**Proposed Subdivision**

**APPLICATION FOR SUBDIVISION PERMIT - SA 2020/00029, 5 Sunnyview Place, Honeywood**

PROJECT  
**5 SUNNYVIEW PLACE,  
HONEYWOOD  
SUBDIVISION**

# **BUSHFIRE HAZARD REPORT**

TITLE  
**OVERALL SITE PLAN**

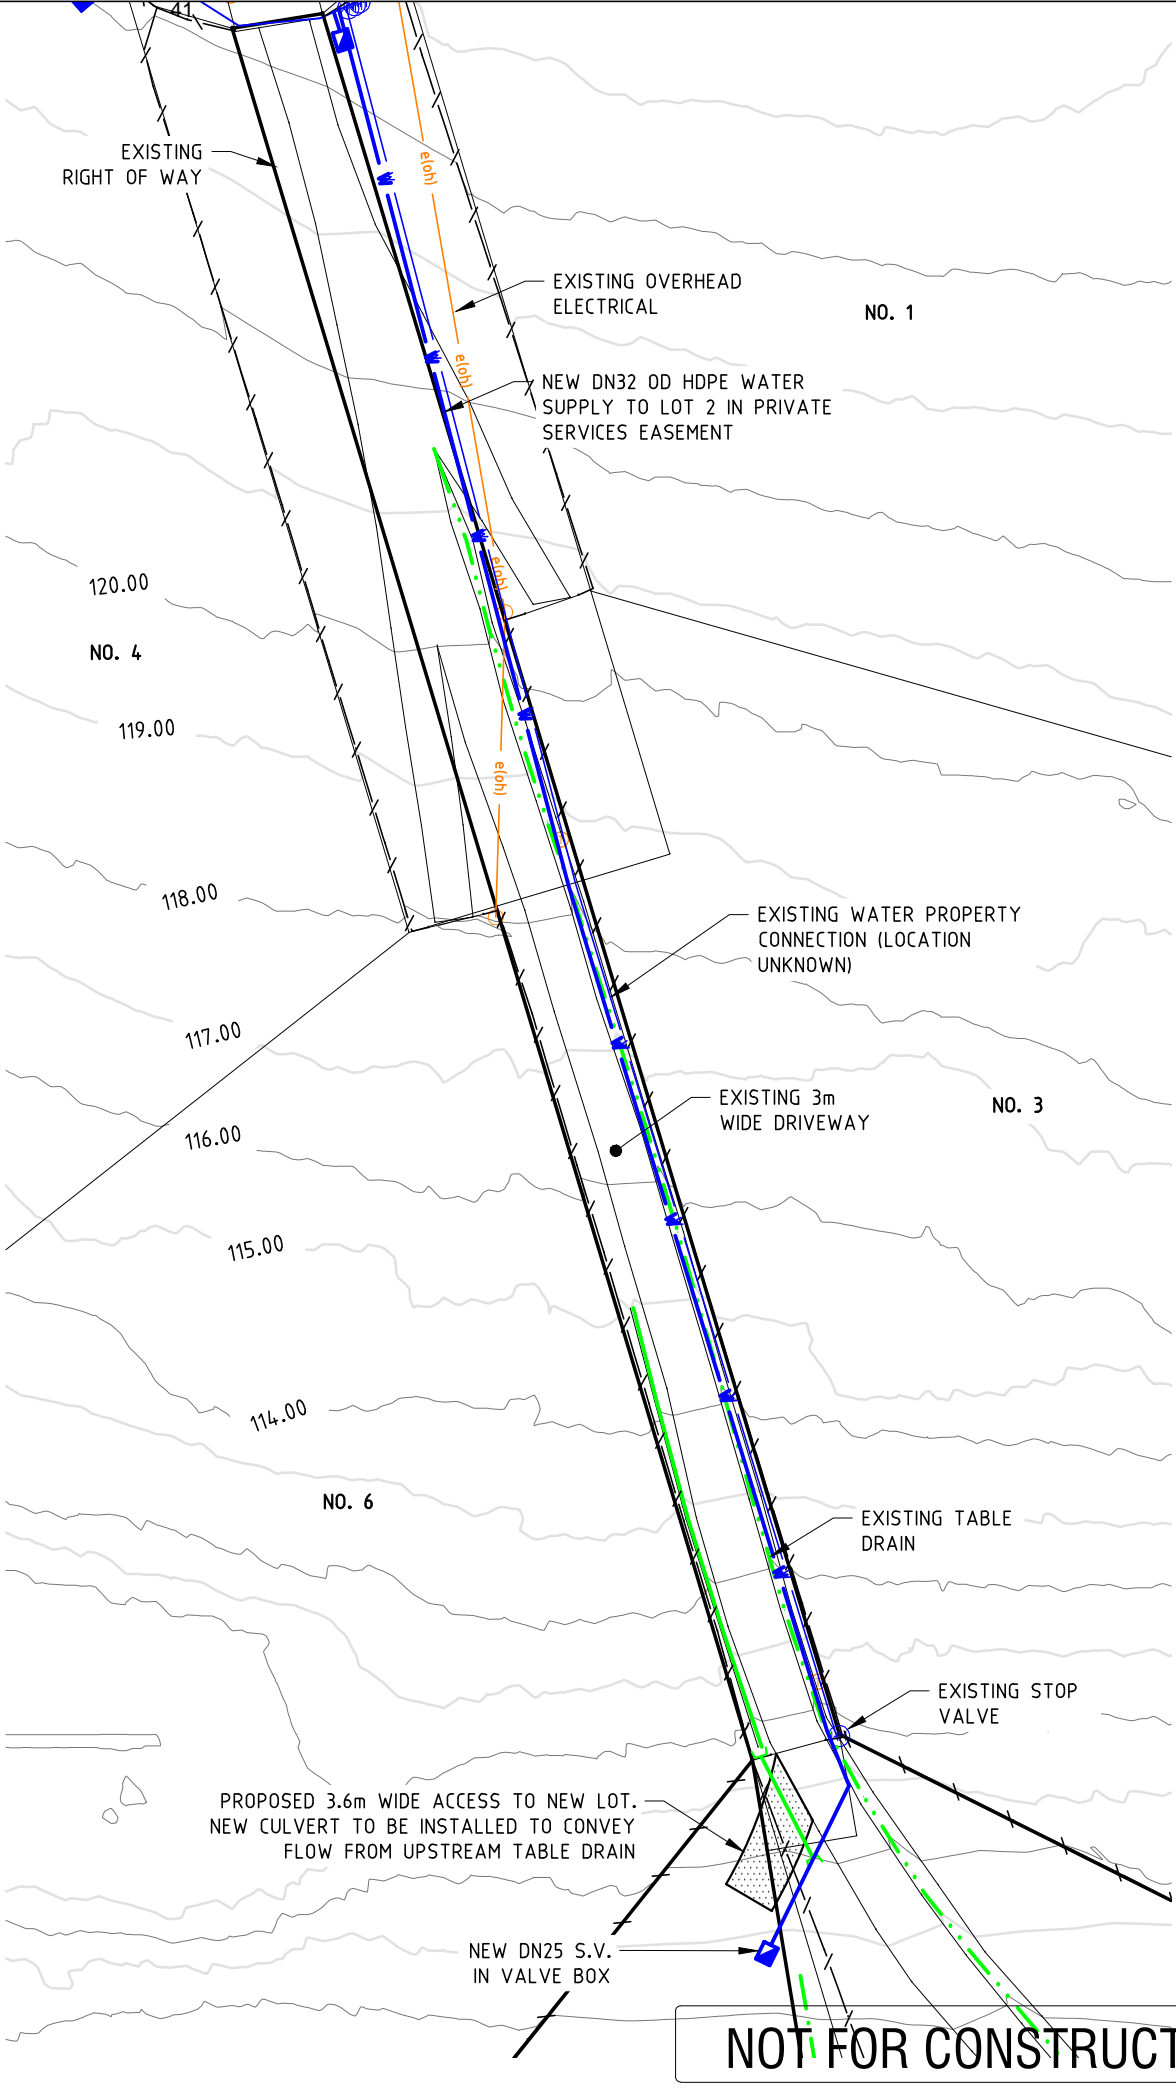
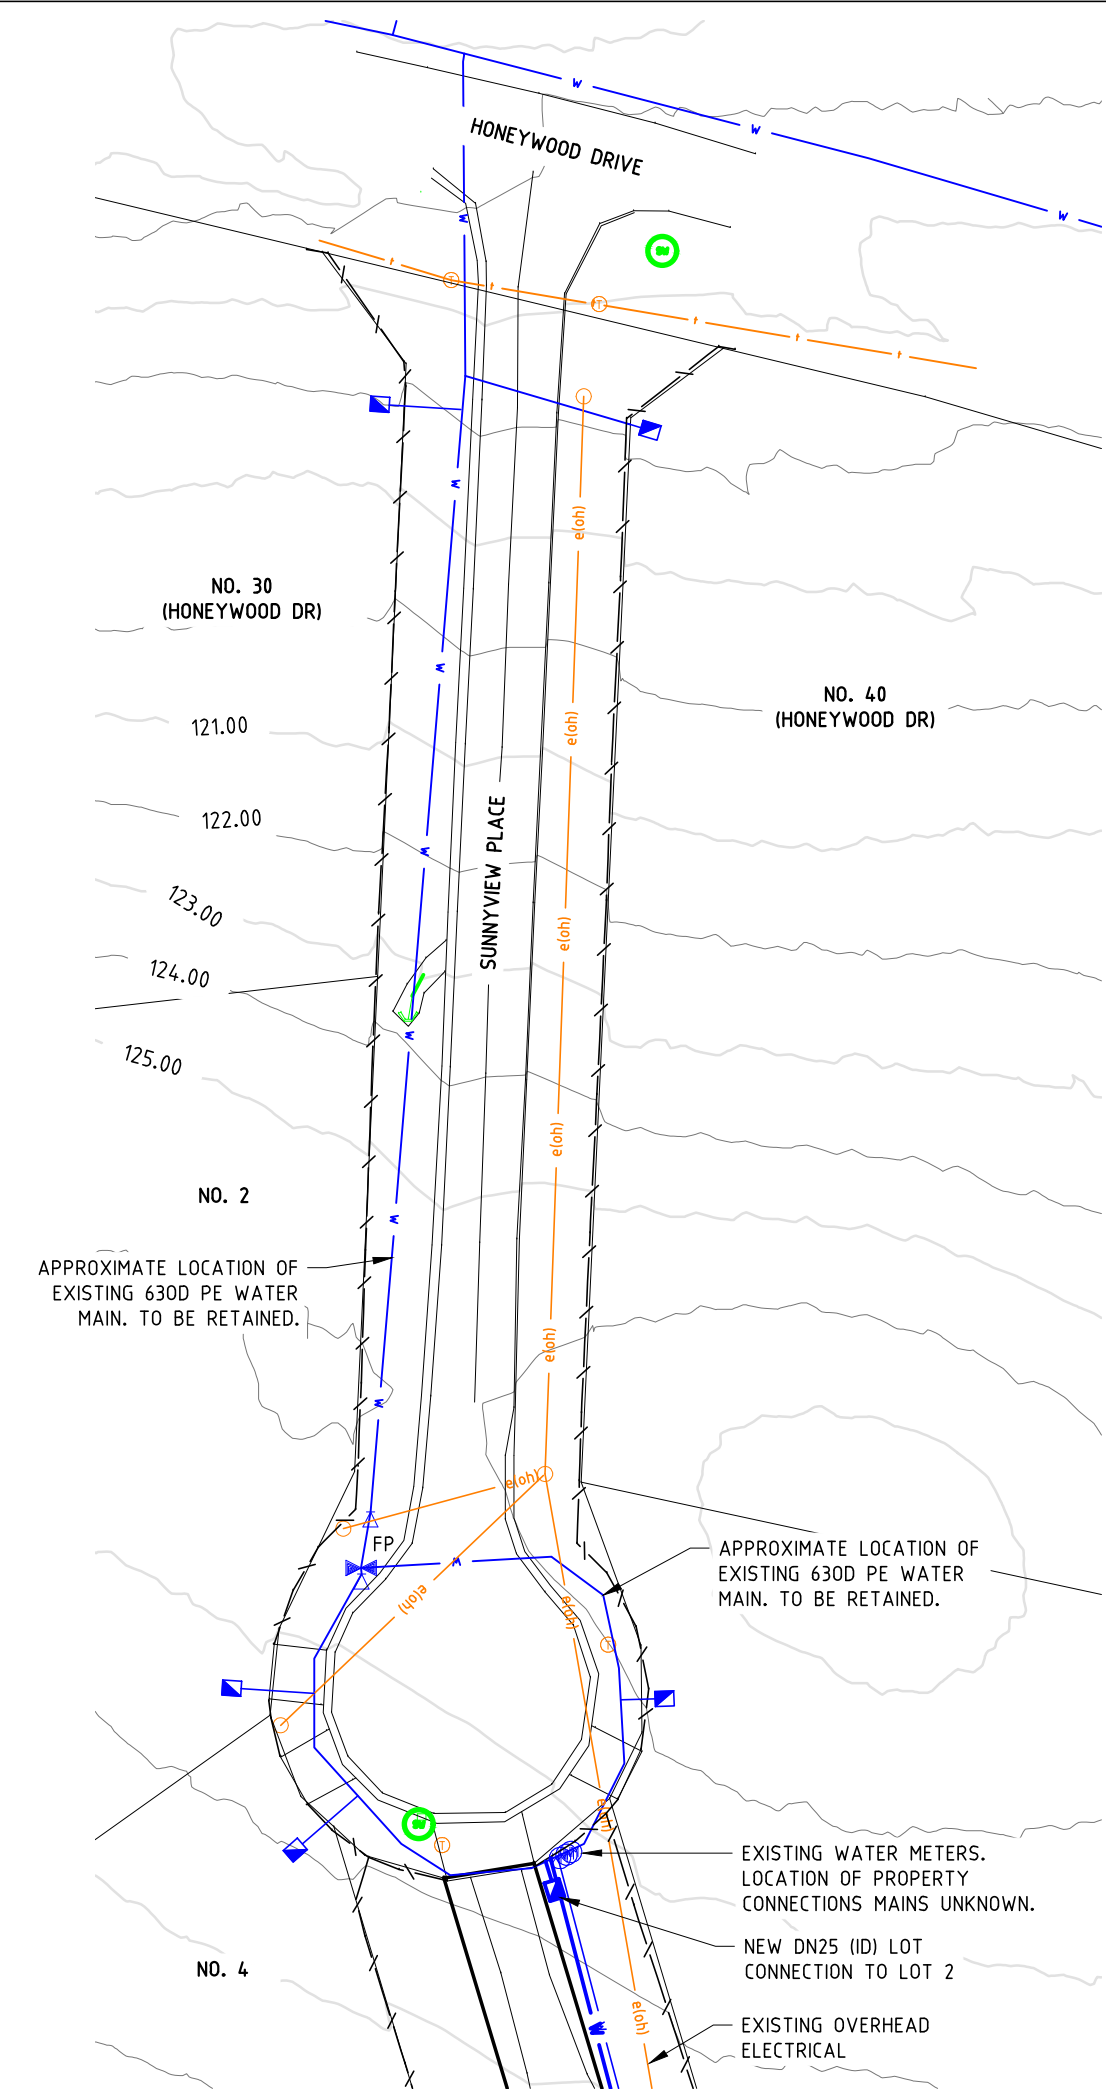
**2. ITEM 2 - CONCEPT SERVICES PLAN**

Concept Servicing Plans to address the following requirements have been prepared and can be found in Attachment A:

- a. Contours showing AHD levels at 2m intervals or less;
- b. Natural drainage lines, watercourses on or adjacent to the site;
- c. The location, capacity of any existing services or easements on the site or connected to the site;
- d. Existing vehicle access to the site and adjoining sites;
- e. Proposed driveways within the site - including any connections to other driveways and how they are to be drained;
- f. Main utility service connection points and easements.

The Concept Servicing Plans found in Attachment A display the water servicing requirements as outlined by TasWater in recent discussions with JMG. A new water meter is provided within the Sunnyview Place cul-de-sac head and the property connection extends down the shared driveway within a private services easement and into the proposed Lot 2.
